PIC18F85J11 Family Silicon Errata and Data Sheet Clarification

The PIC18F85J11 family devices that you have received conform functionally to the current Device Data Sheet (DS39774D), except for the anomalies described in this document.

The following typographic corrections and clarifications are to be noted for the latest version of the device data sheet (DS39774D):

FIGURE 2-3 FREQUENCY vs. ESR PERFORMANCE FOR SUGGESTED VCAP

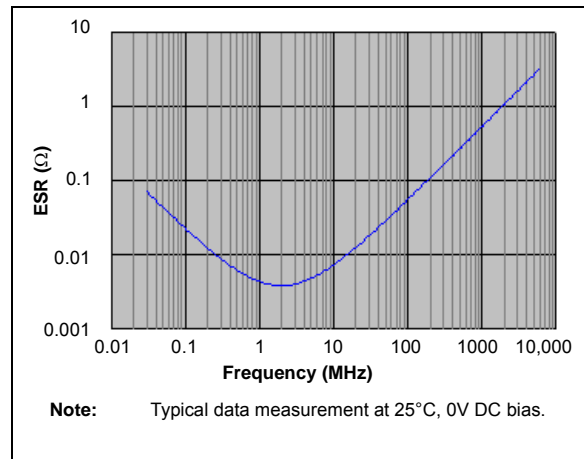
Section 2.4 “Voltage Regulator Pins (ENVREG and VCAP/VDDCORE)” has been replaced with a new and more detailed section. The entire text follows:

When the regulator is enabled, a low-ESR ($< 5\Omega$) capacitor is required on the VCAP/VDDCORE pin to stabilize the voltage regulator output voltage. The VCAP/VDDCORE pin must not be connected to VDD and must use a capacitor of 10 μF connected to ground. The type can be ceramic or tantalum. Suitable examples of capacitors are shown in [Table 2-1](#). Capacitors with equivalent specifications can be used.

Designers may use [Figure 2-3](#) to evaluate ESR equivalence of candidate devices.

FIGURE 2-4 DC BIAS VOLTAGE vs. CAPACITANCE CHARACTERISTICS

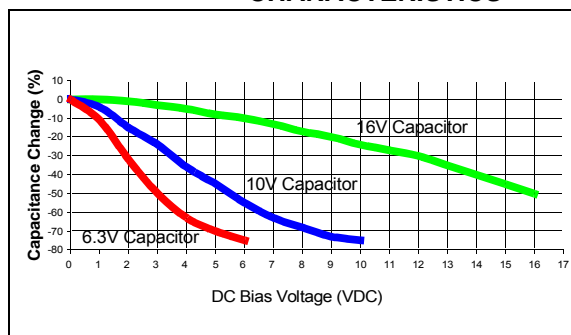
In addition to temperature tolerance, the effective capacitance of large value ceramic capacitors can vary substantially, based on the amount of DC voltage applied to the capacitor. This effect can be very significant, but is often overlooked or is not always documented.

A typical DC bias voltage vs. capacitance graph for X7R type and Y5V type capacitors is shown in Figure 2-4.

When selecting a ceramic capacitor to be used with the VDDCORE voltage regulator, it is suggested to select a high-voltage rating, so that the operating voltage is a small percentage of the maximum rated capacitor voltage. For example, choose a ceramic capacitor rated at 16V for the 2.5V VDDCORE voltage. Suggested capacitors are shown in Table 2-1.
